CITY OF ALBUQUERQUE Planning Department

RE: Good 2 Go: Broadway 1401 Broadway Blvd. SE Grading and Drainage Plan Request for Temp C.O. - Accepted Engineer's Certification Dated 1/5/18 Hydrology File: L14D022

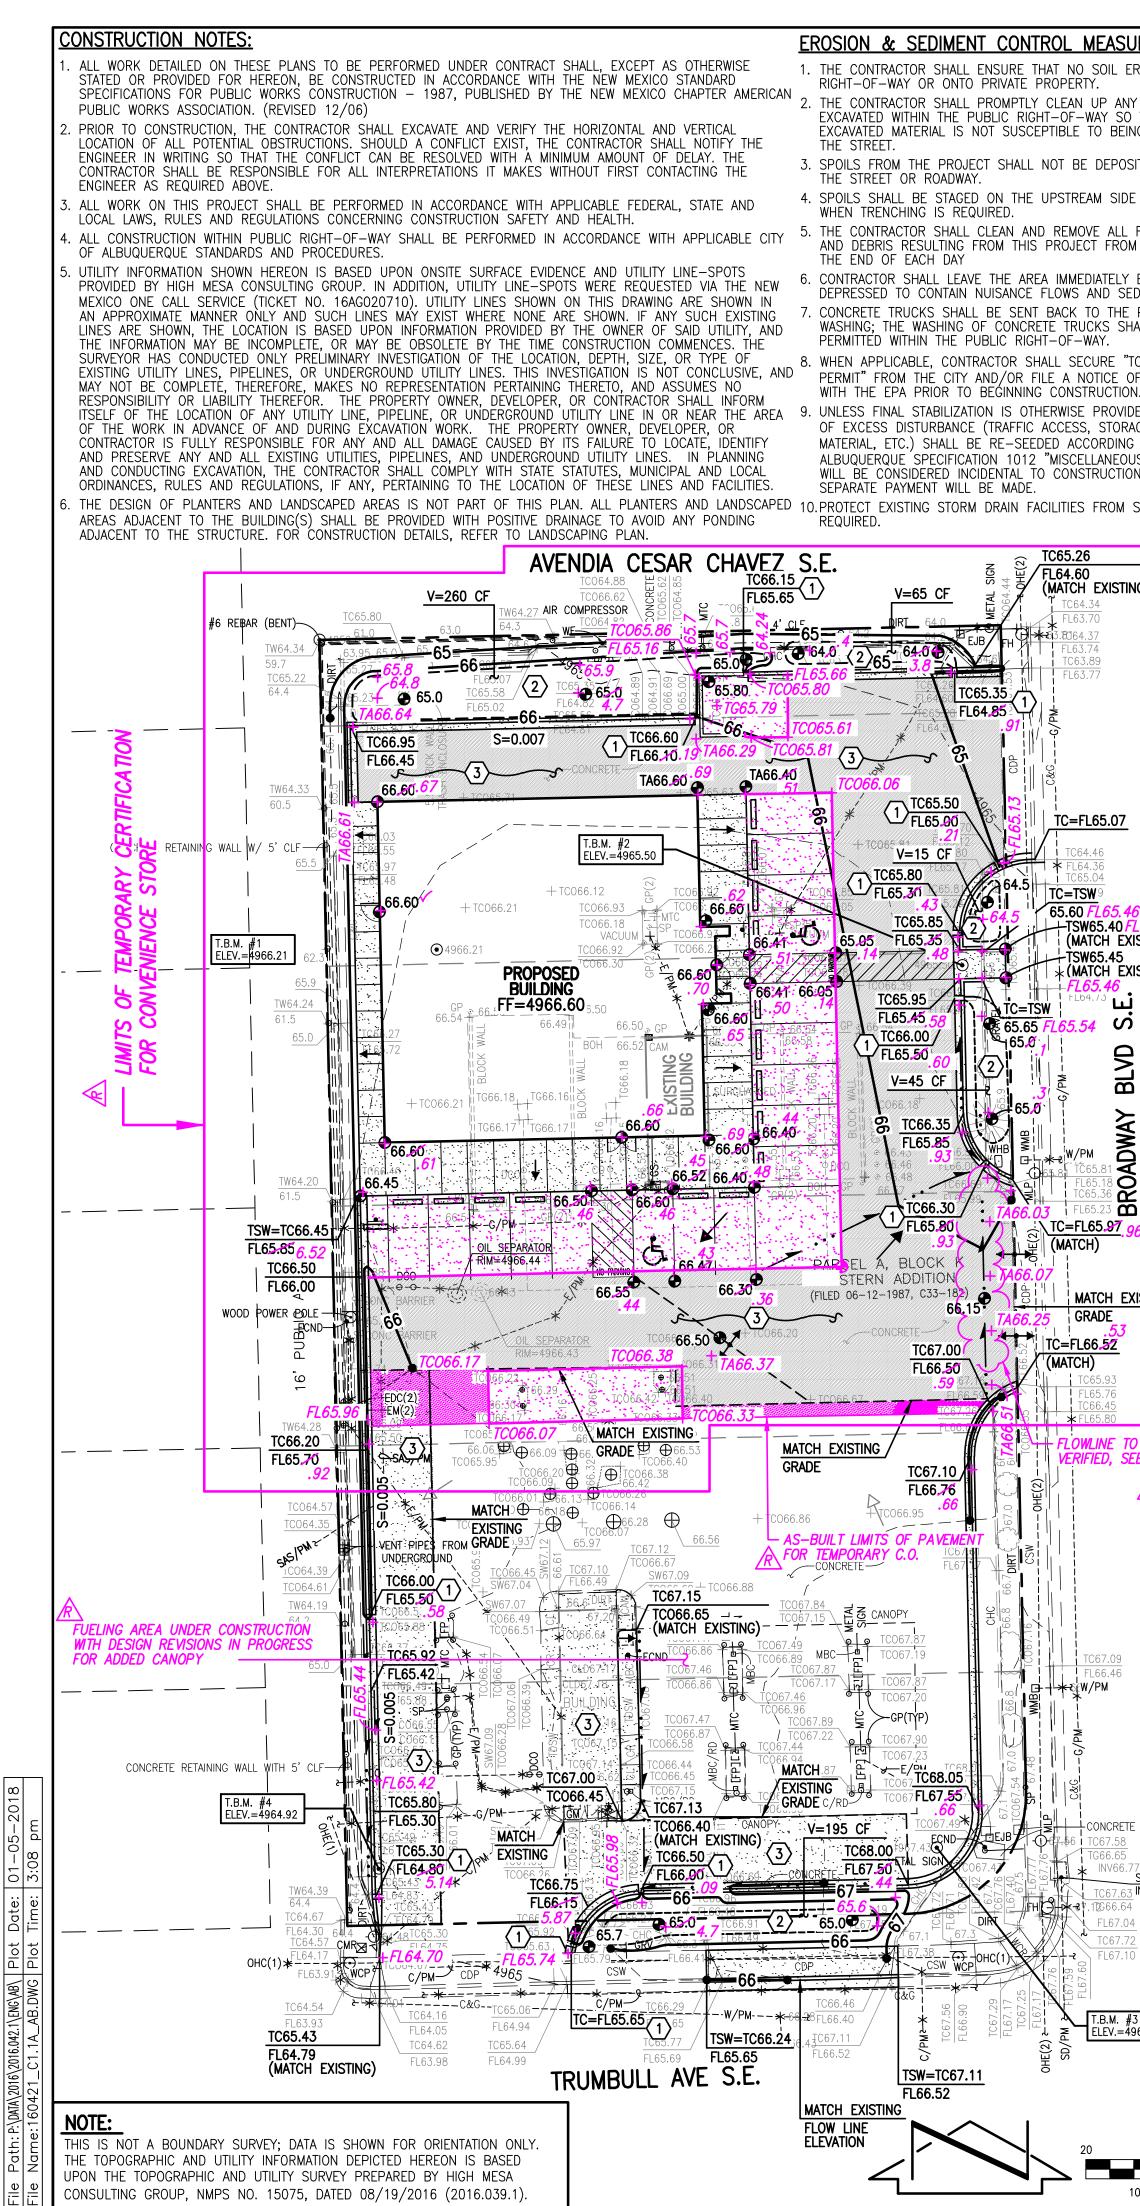
- The fueling area (roughly the south half of the site) must be completed prior to certification for permanent certification of occupancy.
- The north-south flowline west of the southernmost Broadway entrance lacks definition and may not adequately serve to direct runoff to the water quality basin. This area shall be flow tested in the presence of the engineer. If tested does not indicate compliance with the intent, then pavement correction will be required.
